MIL-C-17587B(SH)
AMENDMENT 1
1 July 1986

MILITARY SPECIFICATION

CIRCUIT BREAKERS, LOW VOLTAGE, ELECTRIC POWER, AIR,
OPEN FRAME, REMOVABLE CONSTRUCTION

This amendment forms a part of MIL-C-17587B(SH), dated 18 April 1983, and is approved for use by the Naval Sea Systems Command, Department of the Navy, and is available for use by all Departments and Agencies of the Department of Defense.

FIGURE 1. Outline and mounting dimensions for circuit breaker type ACB-900R.

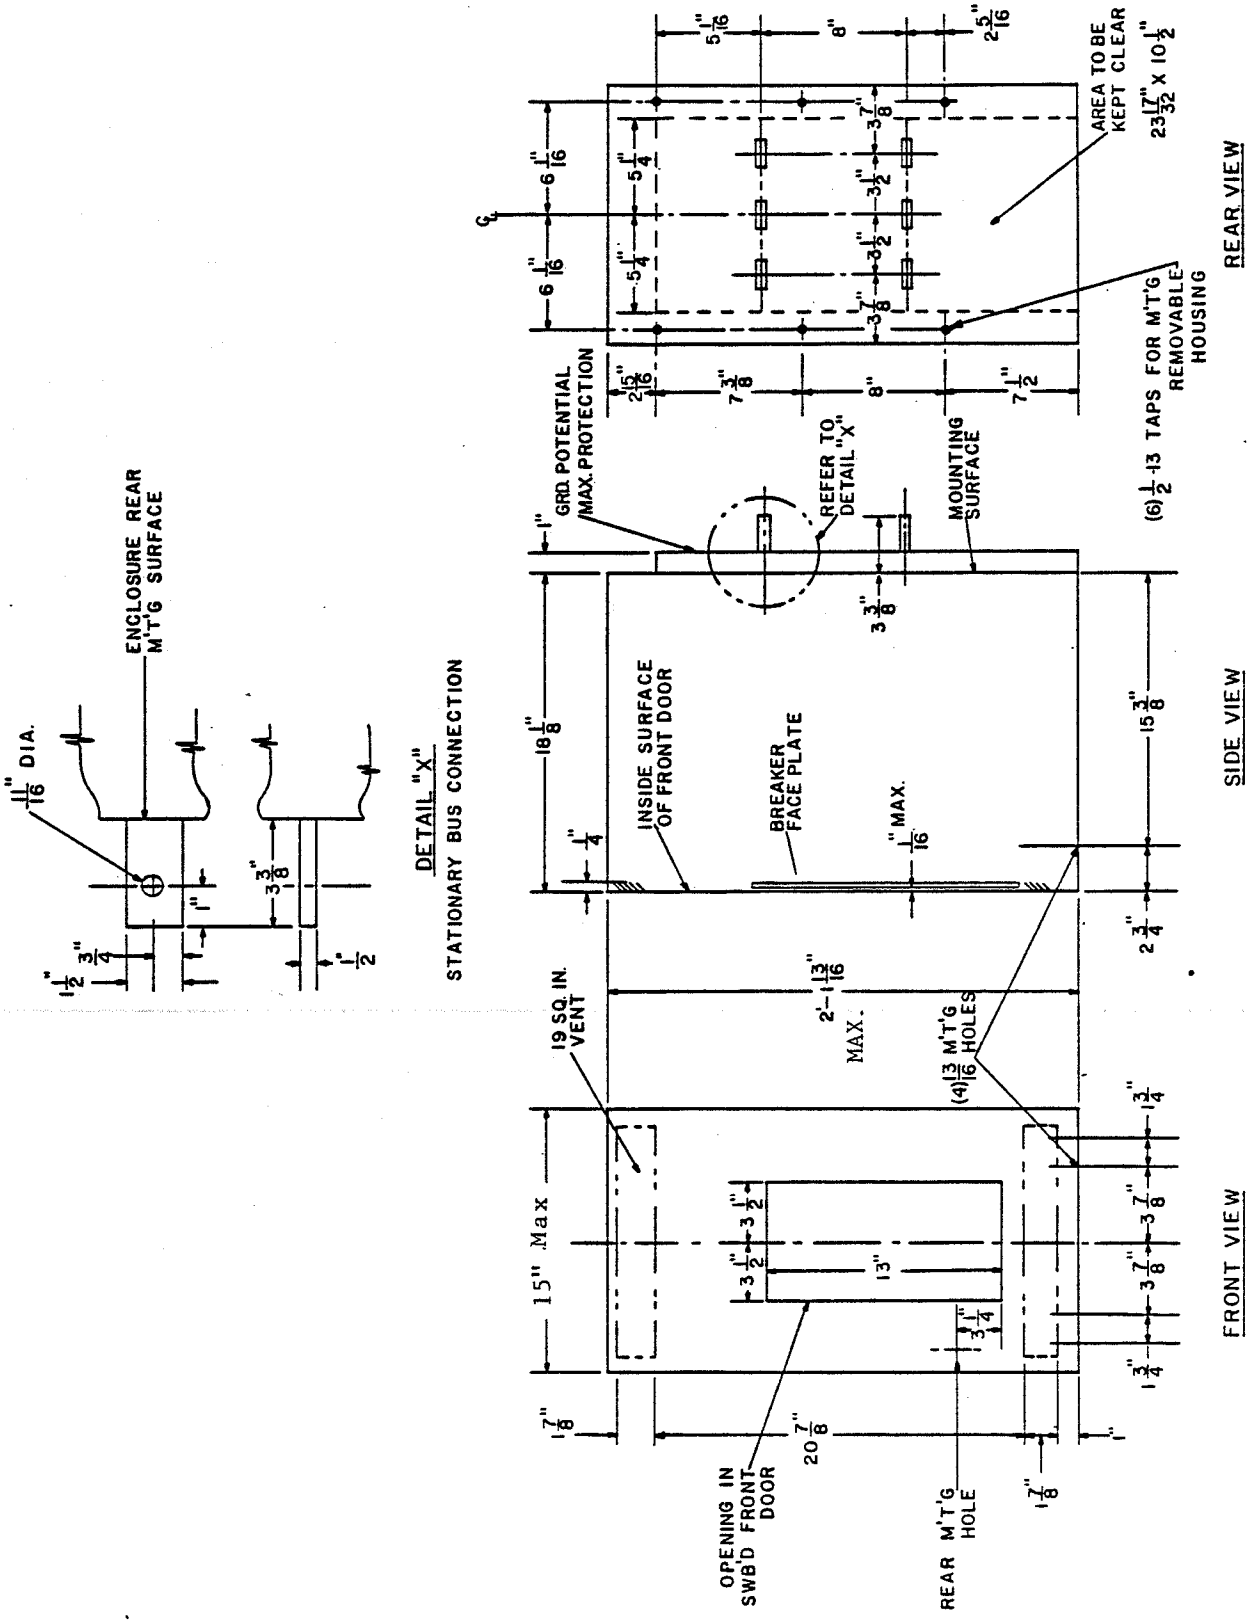
Figure 1: Delete and substitute:

FIGURE 2. Outline and mounting dimensions for circuit breaker type ACB-901R.

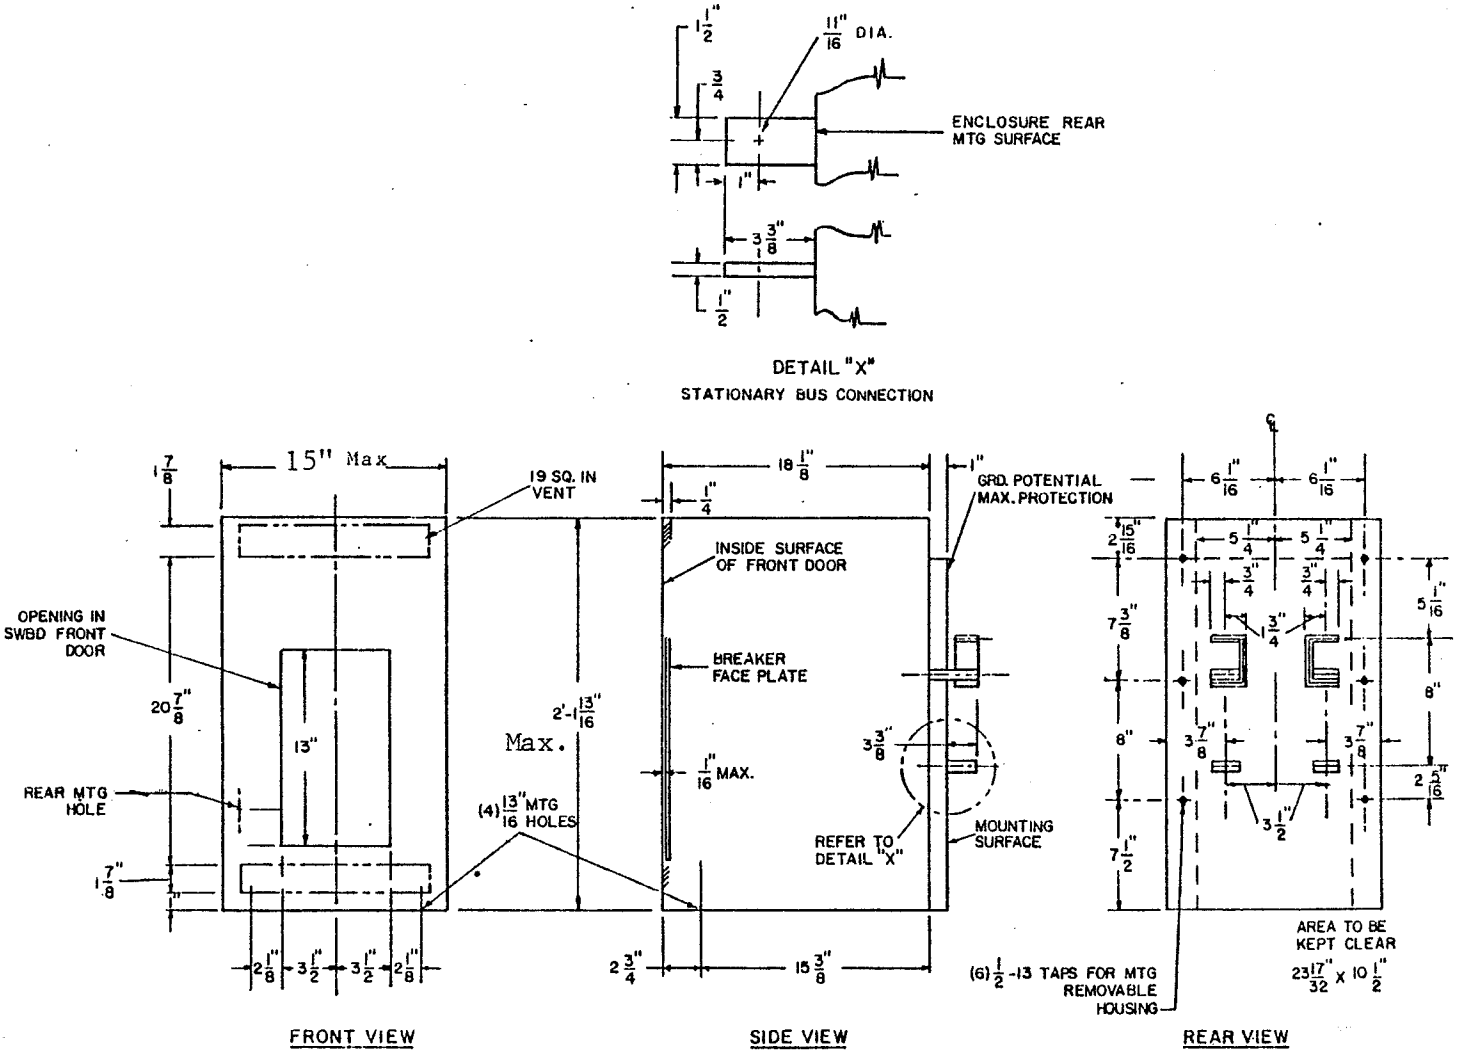
Figure 2: Delete and substitute:

FIGURE 4. Outline and mounting dimensions for circuit breaker types ACB-1600HR, ACB-2000R, 2000LR, and 2601R.

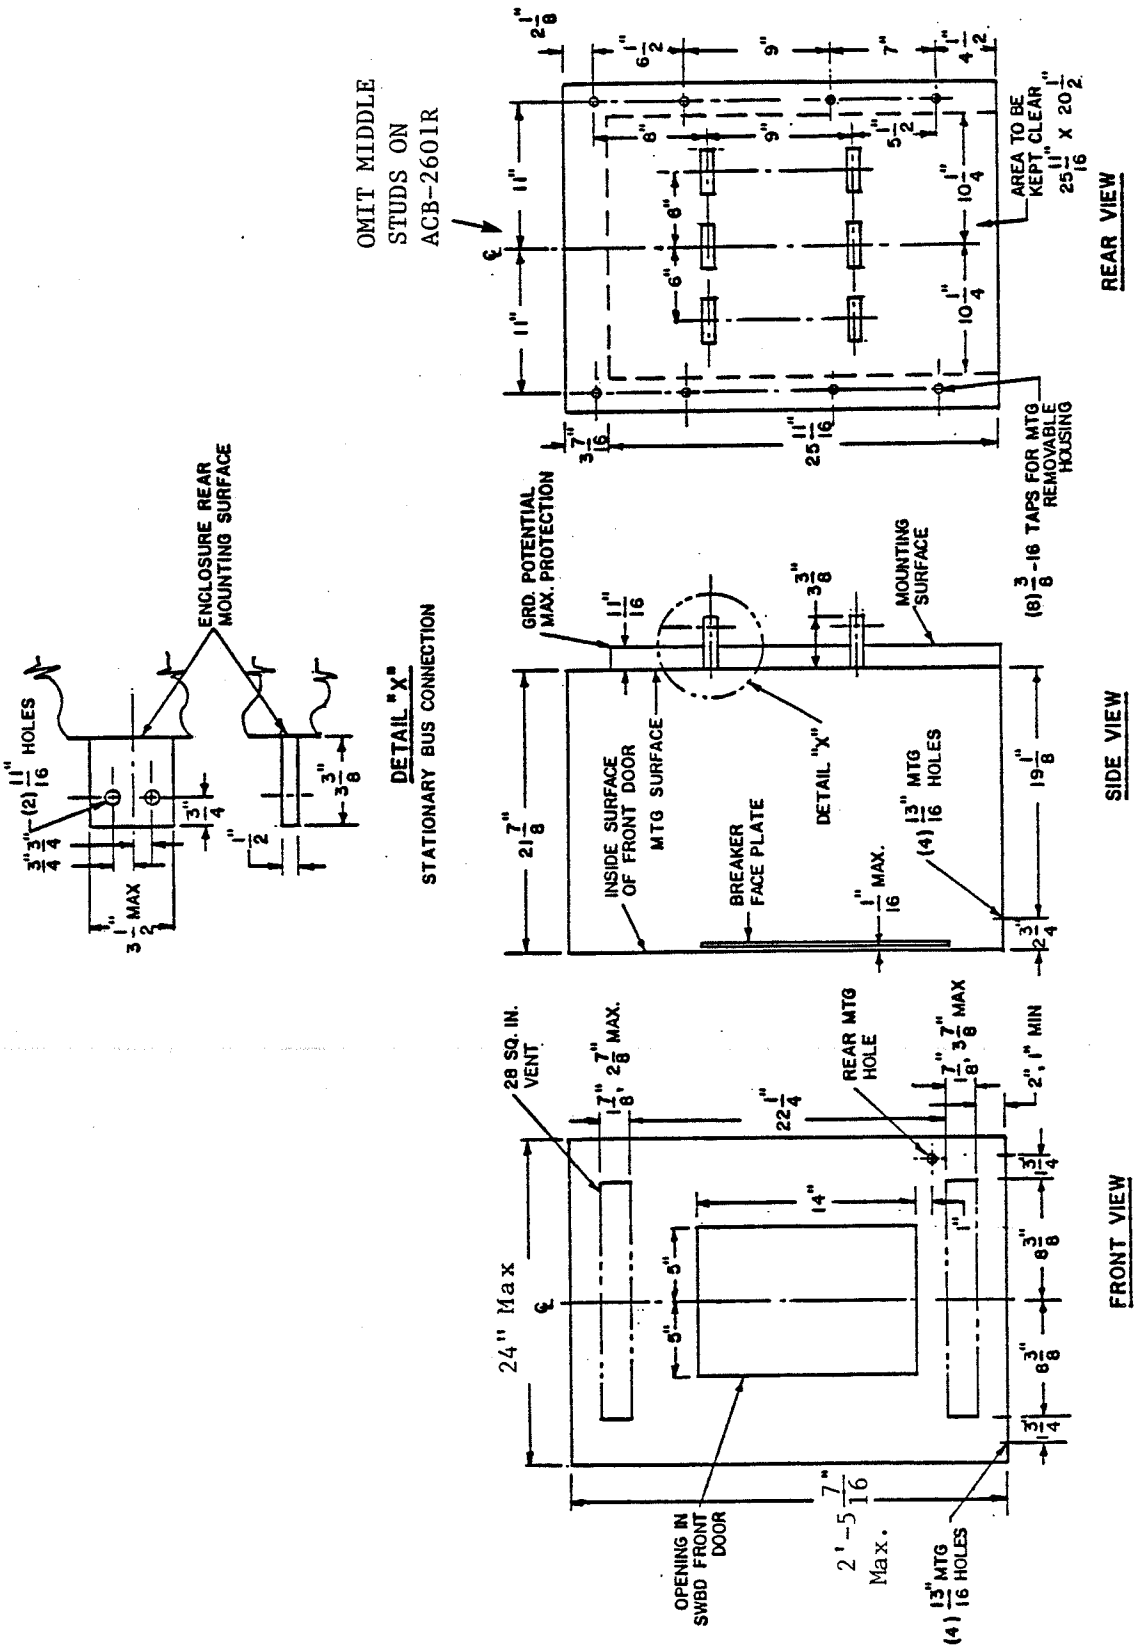
Figure 4: Delete and substitute:

FIGURE 5. Outline and mounting dimensions for circuit breaker type ACB-2002HR.

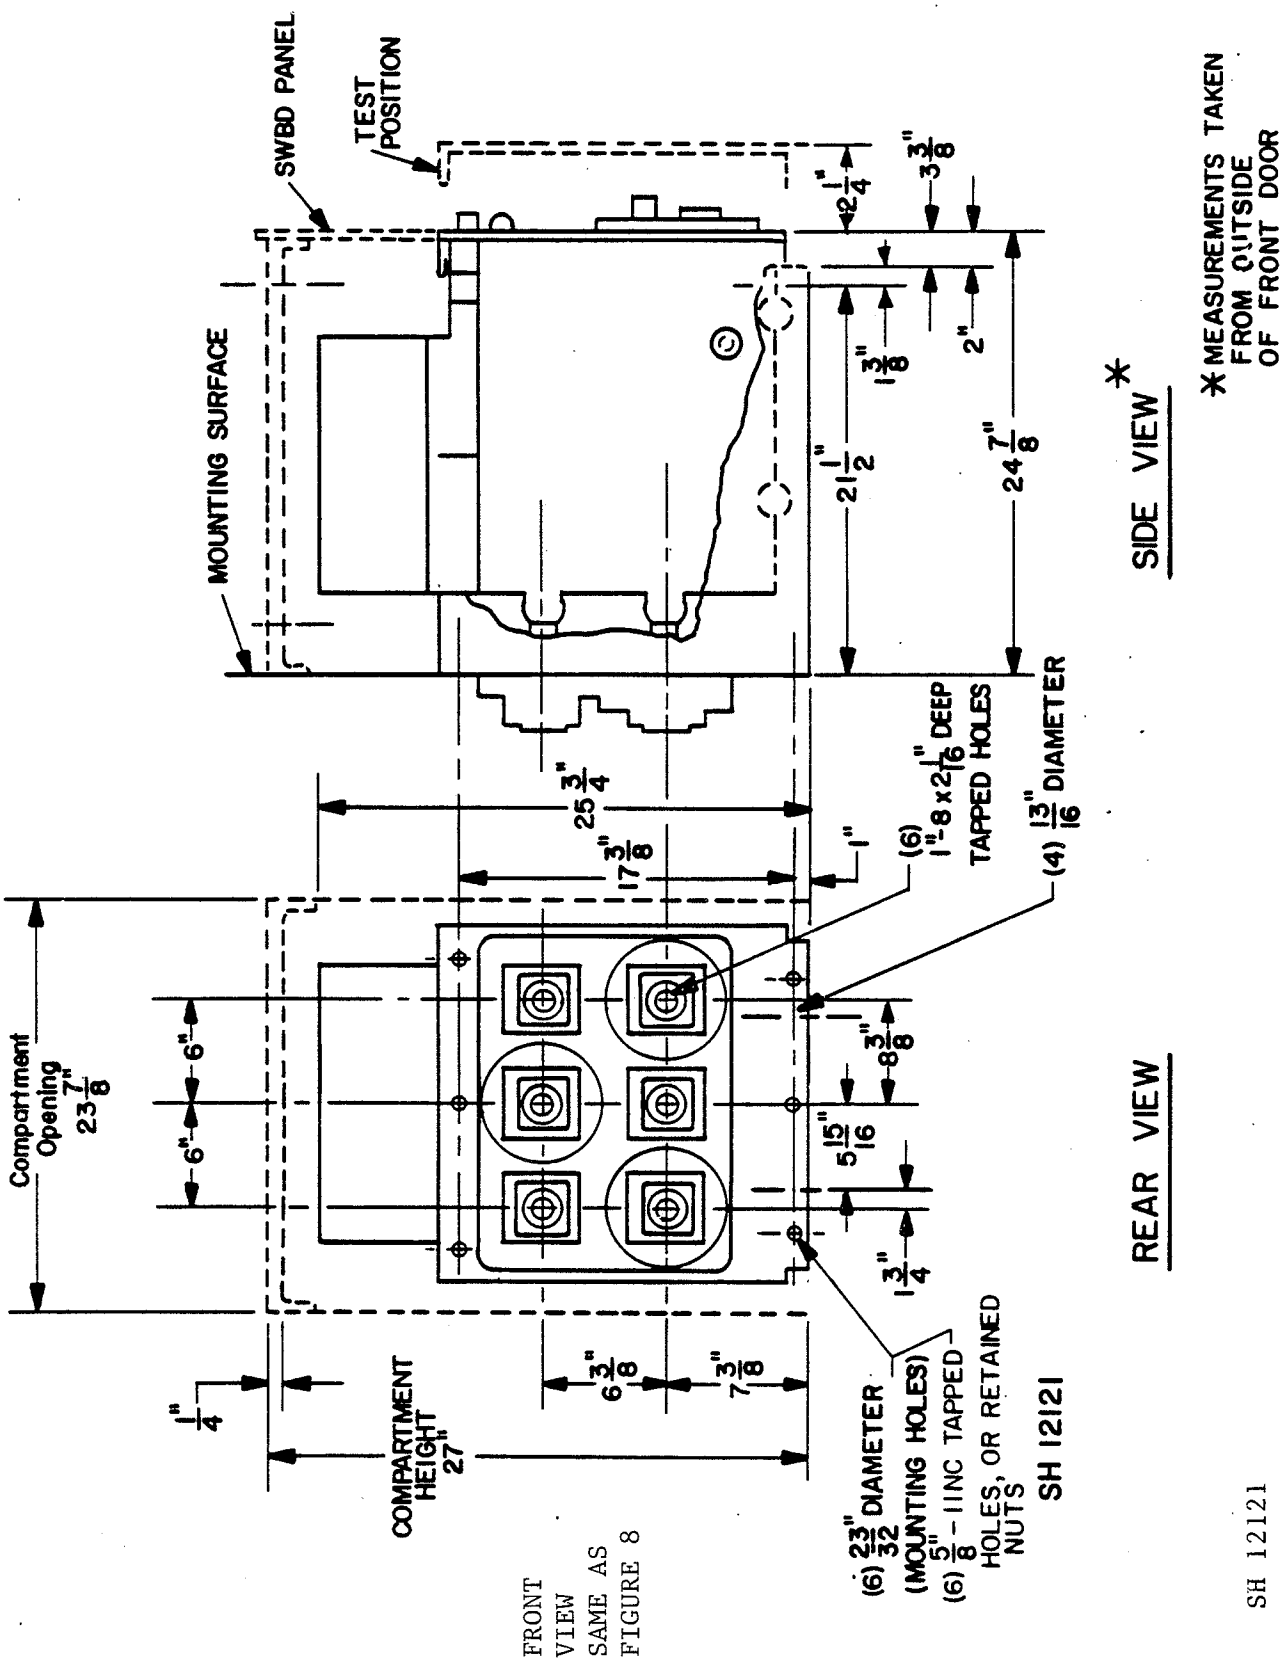
Figure 5: Delete and substitute:

FIGURE 7. Outline and mounting dimensions for circuit breaker types ACB-3200HR, ACB-4000HR and ACB-5001R.

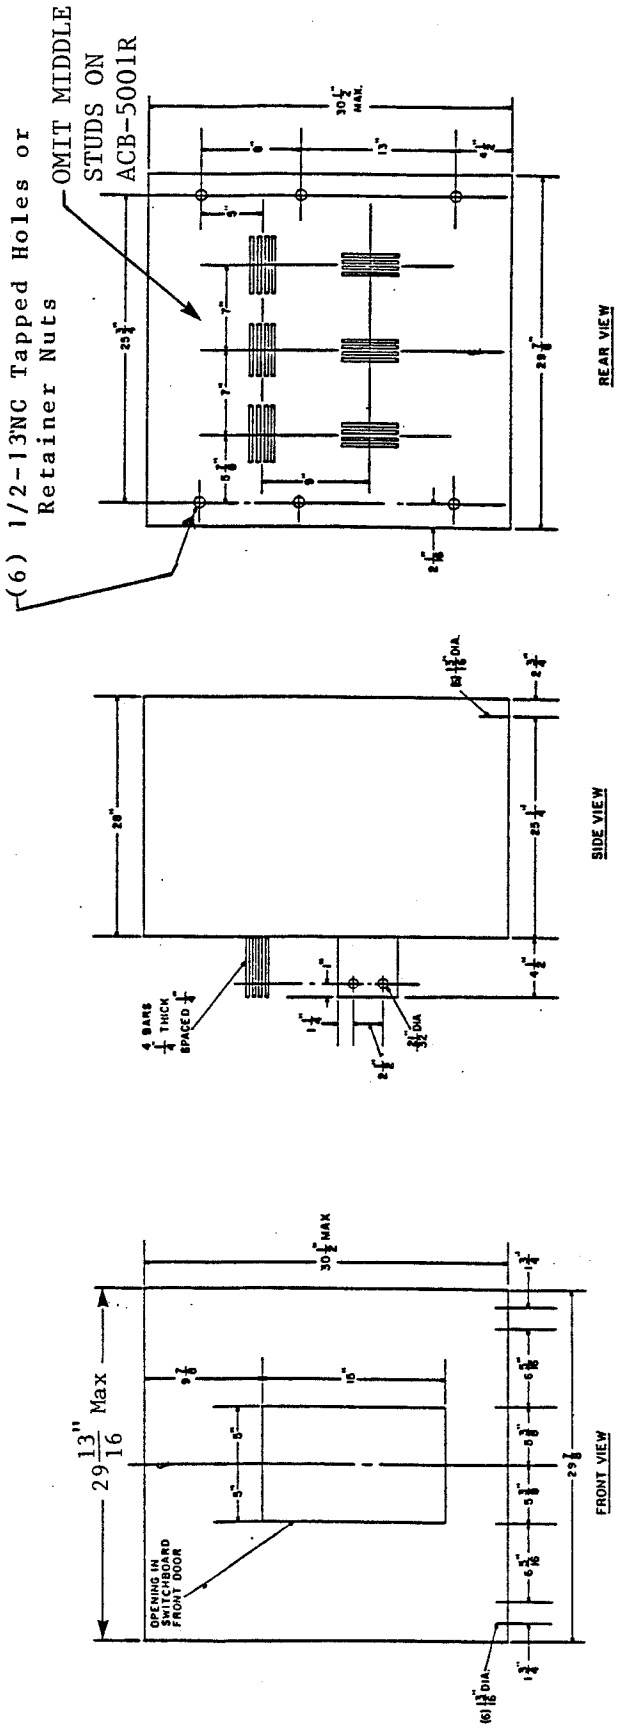
Figure 7: Delete and substitute:

FIGURE 8. Outline and mounting dimensions for circuit breaker type ACB-4001R.

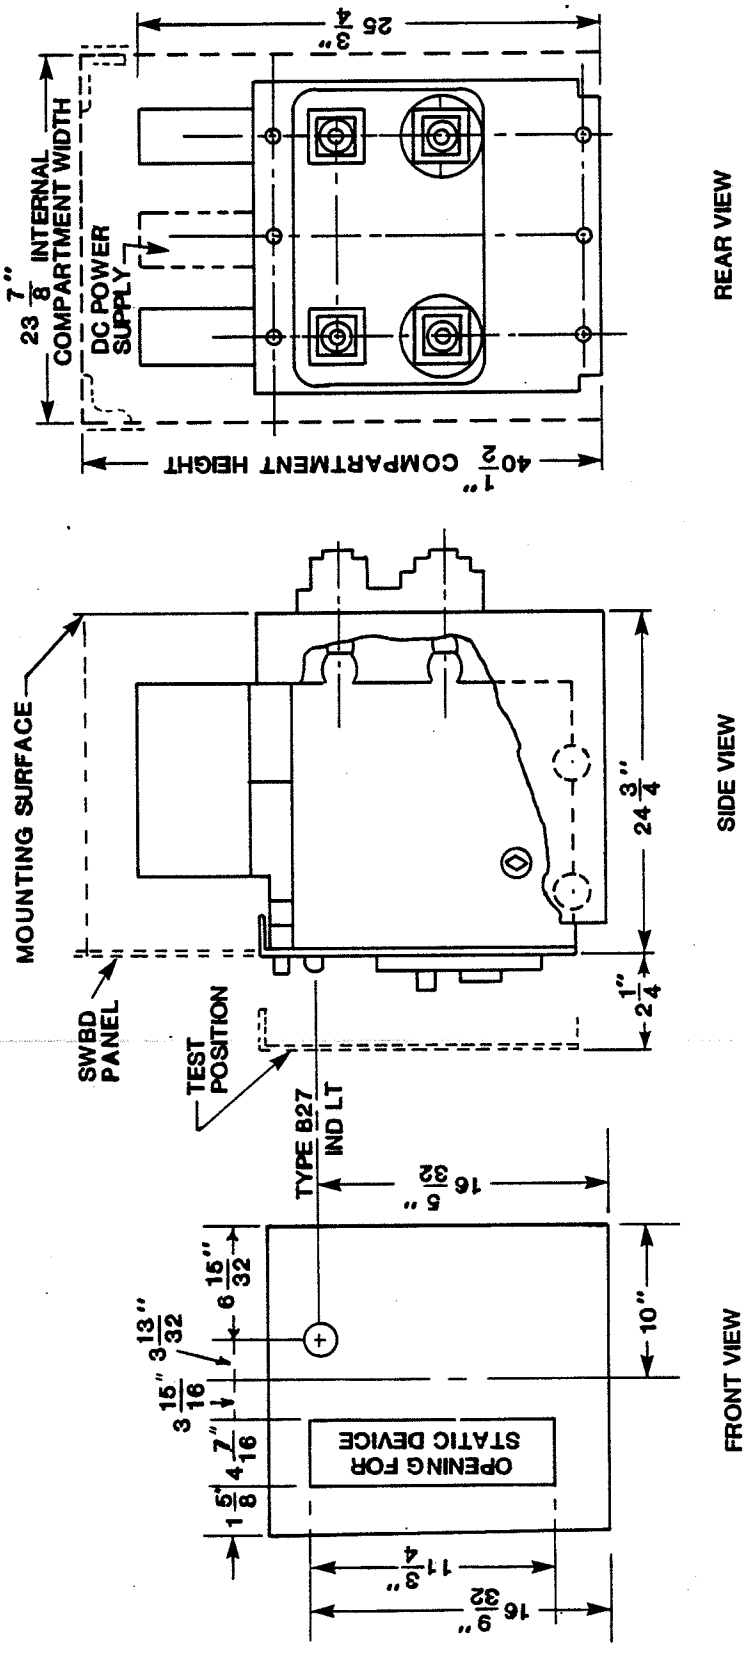
Figure 8: Delete and substitute:
